RE: Bernhardt Sand and Gravel Pit, File No. M-2023-025,
112c Permit Application, Second Adequacy Review

WW Clyde & Co. (WW Clyde) has received the Division's Second Adequacy Review letter dated April 17, 2024. Below are the comments and the corresponding responses that we have provided to address the comments.

RE: *Bernhardt Sand and Gravel Pit, File No. M-2023-025*
112c Permit Application, Second Adequacy Review
May 21, 2024

Exhibit C2 - Mining Plan Map

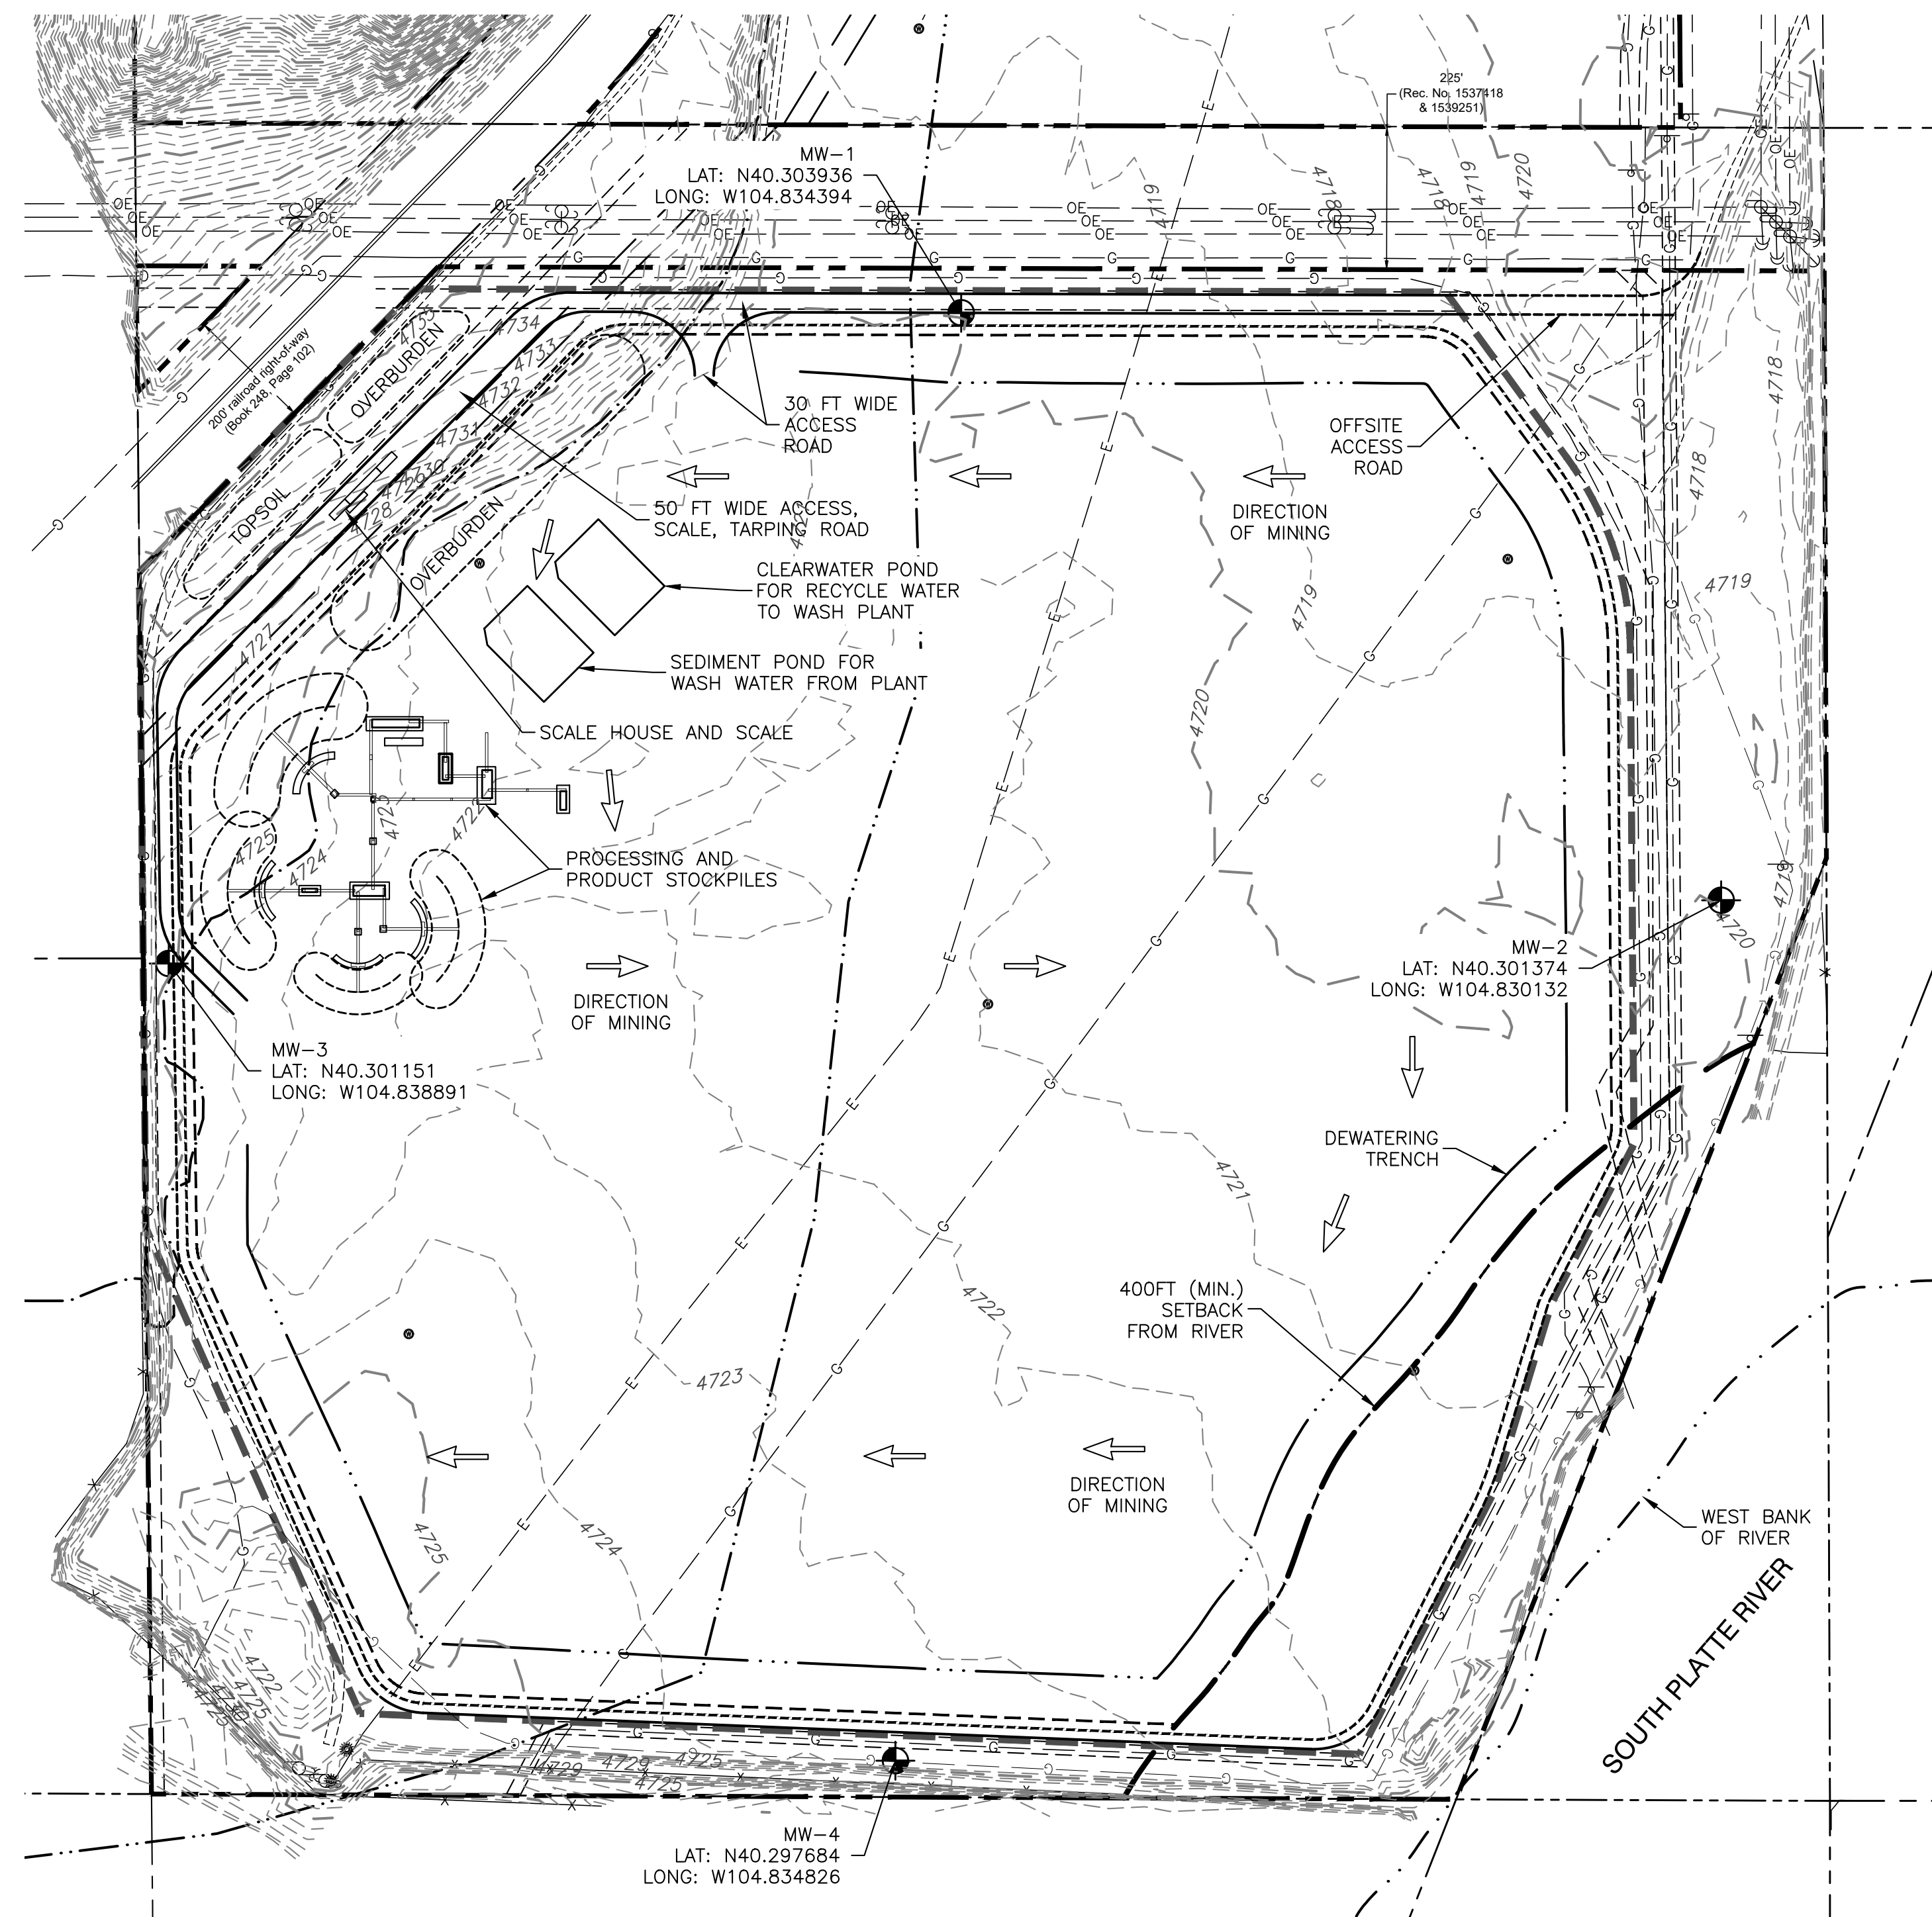
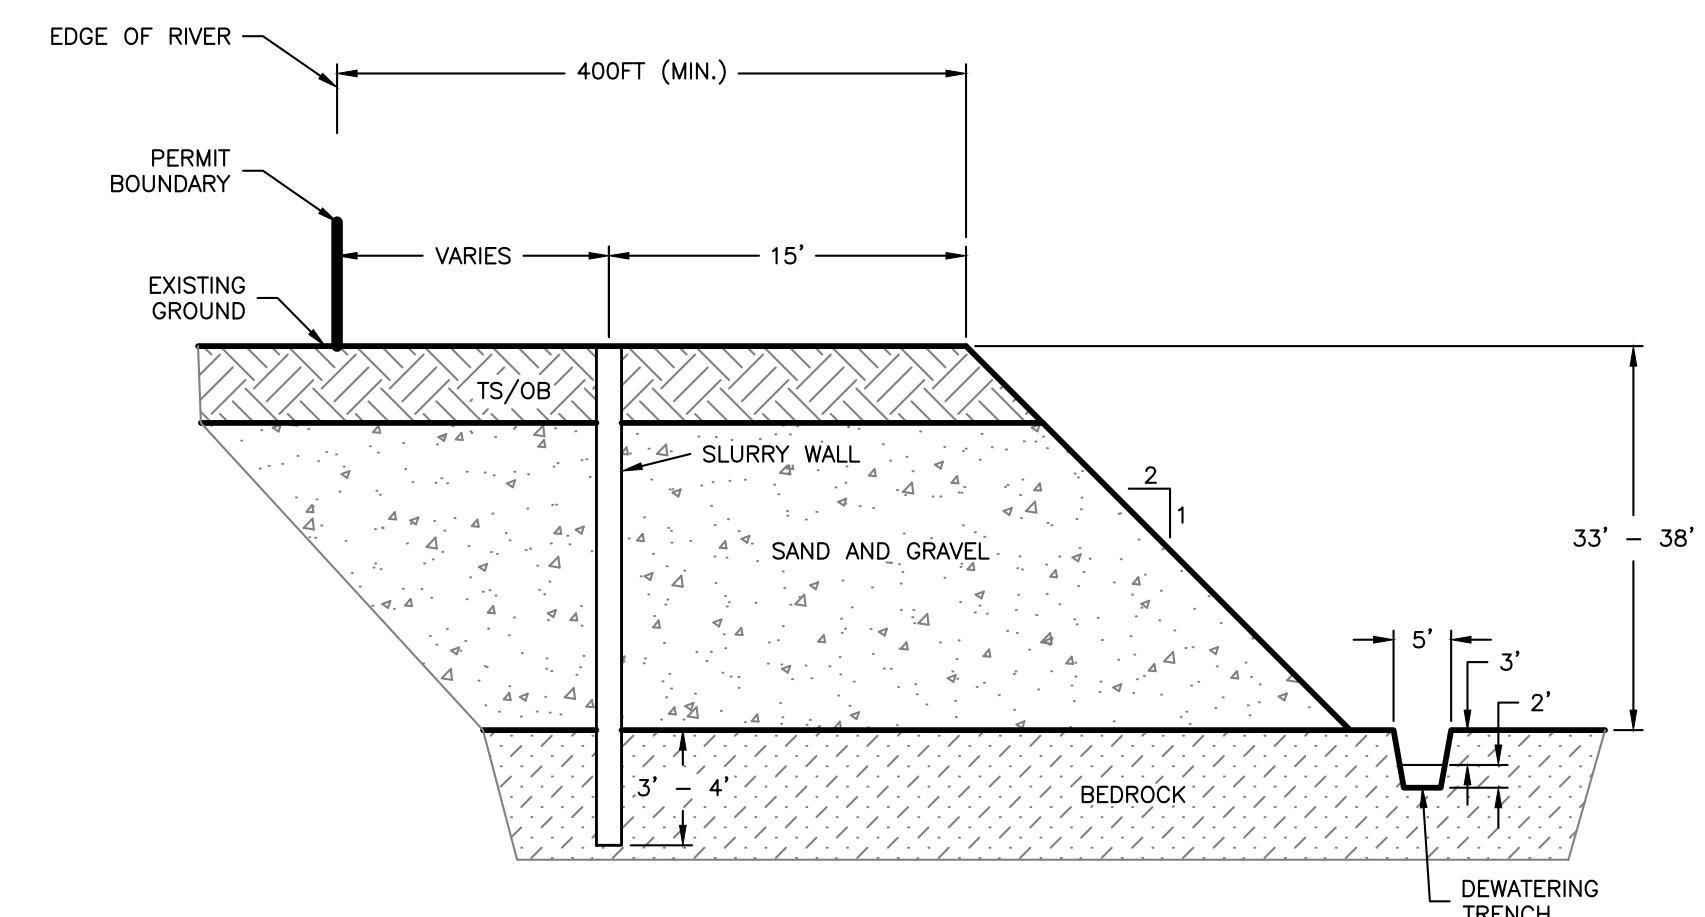
3) The South Platte River must be shown and labeled on maps C-1 and C-2, per Rule 6.4.3(b).

No additional response required, but it is suggested that the symbology and legend on the maps in Exhibit C be improved. The same symbol is used for the dewatering trench and the edge of the river; this is confusing. Also, the term "Edge of River" is not clear; should it be "West Bank" instead? The 400-foot setback is not included in the legend.

4) Please discuss if processing will entail washing of the product and if a pond or ponds will be included in the process area. If so, add a discussion to the text of Exhibit D and to Map C-2.

The Direction of Mining arrows on Map C-2 imply that mining will occur in the area where the Sediment Pond and Clearwater Pond will be constructed. Please explain in Exhibit D if these ponds will be constructed after this area is mined and how that impacts the process of washing material. Will the ponds need to be constructed twice during the life of the mine?

Response: Acknowledged. See updated maps.

Response: The ponds will be constructed once and the area will be mined at the

end of the mining when no washing will be occurring once the final mining is completed with the final reclamation.

PERIMETER GROUNDWATER DRAIN
(TYPICAL SECTION IF REQUIRED)
N.T.S.

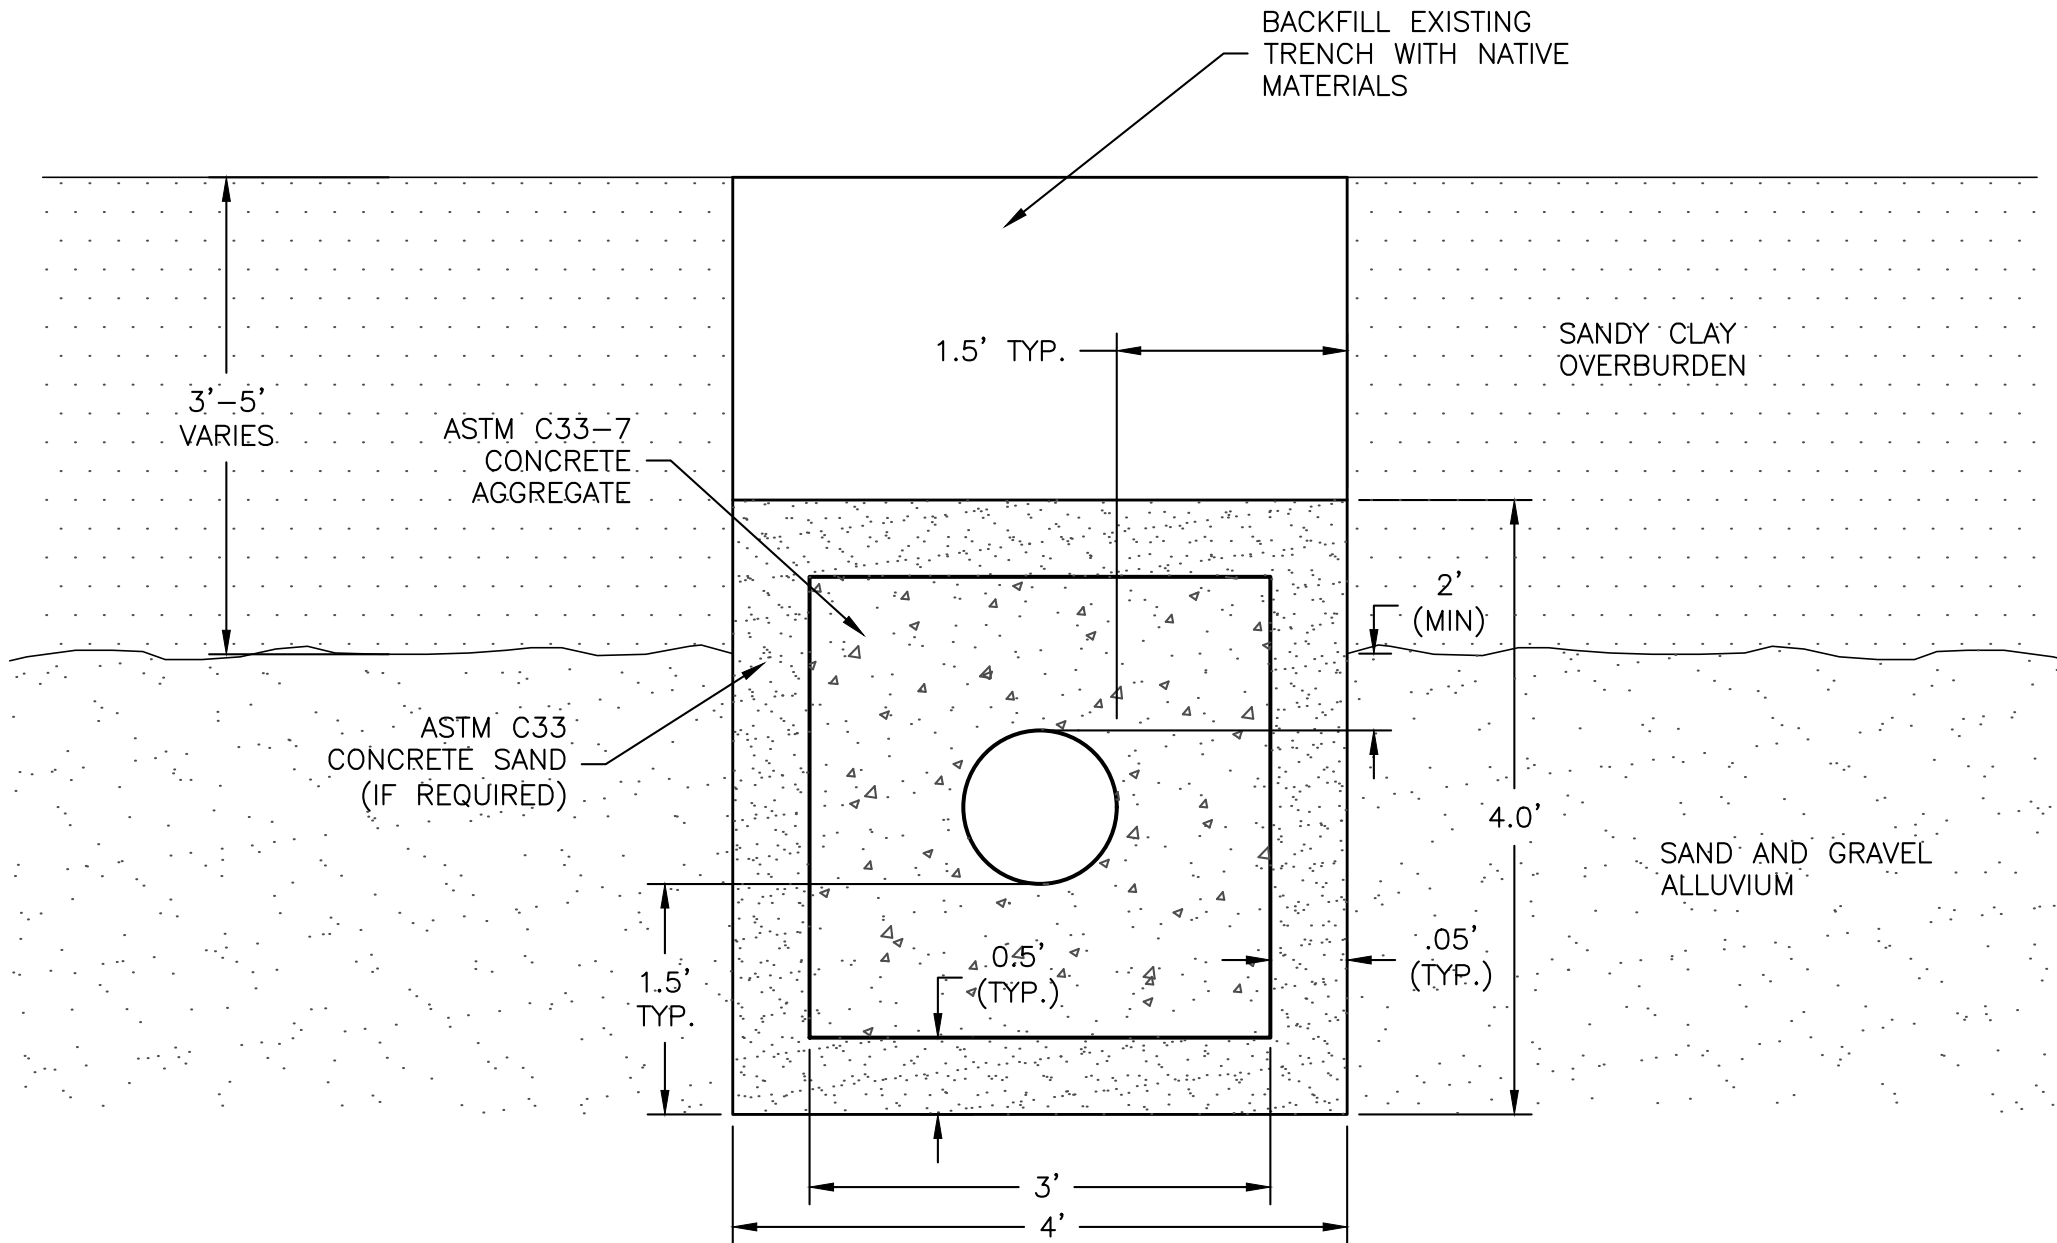
5. Exhibit G needs to be updated with a discussion of mitigation measures regarding groundwater mounding approaching the surface. Include in the discussion triggers for the initiation of mitigation measures.

Response: The first mitigation measure will be the construction of a groundwater drain as detailed in the McGrane response attached. The design and construction of the groundwater drain will be at the same time the slurry wall design and construction are completed so there will be minimal affect on the groundwater elevations. The drain will be constructed to a depth deep enough to control groundwater mounding from surfacing. Stop logs will be used to control groundwater elevations such that the drain does not drop the elevation to much or raise the elevation where mounding could occur. The trigger points would be levels of plus or minus 2 feet of difference from the baseline seasonal groundwater levels in MW-1 through MW-4 where stop log elevations could be adjusted to either lower or raise groundwater levels to their historic seasonal elevations. See the updated Exhibit G and updated text with

Figure 1 – Change Associated with the Pit Liner (Report Figure A10 with Labels)

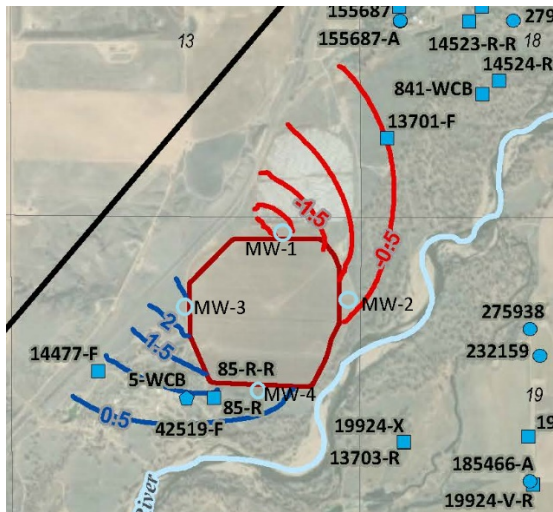
“In review of Figure 10A along with the predicted mounding of ~2.5 feet on the upstream side of the proposed permit boundary, it appears the predicted mounding combined with high groundwater levels seen in July 2023 will bring groundwater elevations to within 0.5 feet of ground surface at MW-3. Additionally, extrapolating the potential mounding groundwater elevations during high groundwater levels away from the permit boundary in the southwestern area, it appears that the mounding will result in groundwater being exposed at the surface.

As discussed in the modeling report, the contours show upgradient mounding and downgradient shadowing in the range of +/- 2.5 feet.

Figure 2 – Drain Run (Drain Elev. 4818 ft.)

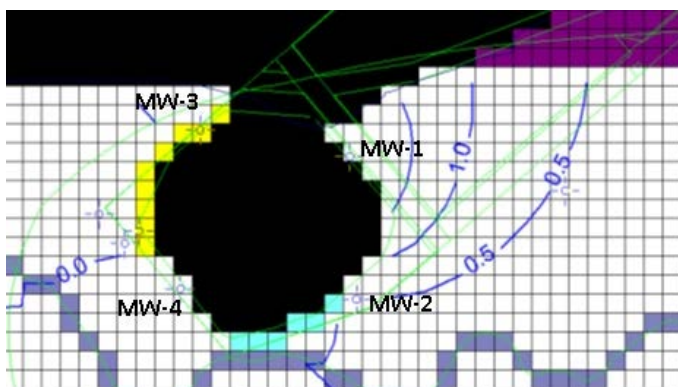
“Please provide a groundwater model analysis to demonstrate how effective installing the proposed underdrain will be to mitigate the predicted groundwater mounding on the upstream side of the proposed slurry wall.”

In drain run <Bern_SS9_d4>, we establish an upgradient drain at elevation 4718 ft (yellow cells). The resulting mounding (**Figure 2**) compared to the pre-pit run at MW-3 (+0.33) and MW-4 (+0.52 ft) are insignificant, but the downgradient shadowing in MW-2 (-0.44 ft) and MW-1 (-2.54 ft) provides only a minor improvement over the non-drain pit impact run (**Figure 1**). We suspect that most of the exfiltrating groundwater recharges the SPR instead of filling up the shadow zone further to the west. We believe this is not a big problem since there are no downgradient wells within the shadow zone. The modeled drain flow is approximately 260 gpm.

If we add the maximum “change” caused by the drain to the observed shallowest level measurement in July, then the predicted depth to water in upgradient wells (MW-3 to MW-4)
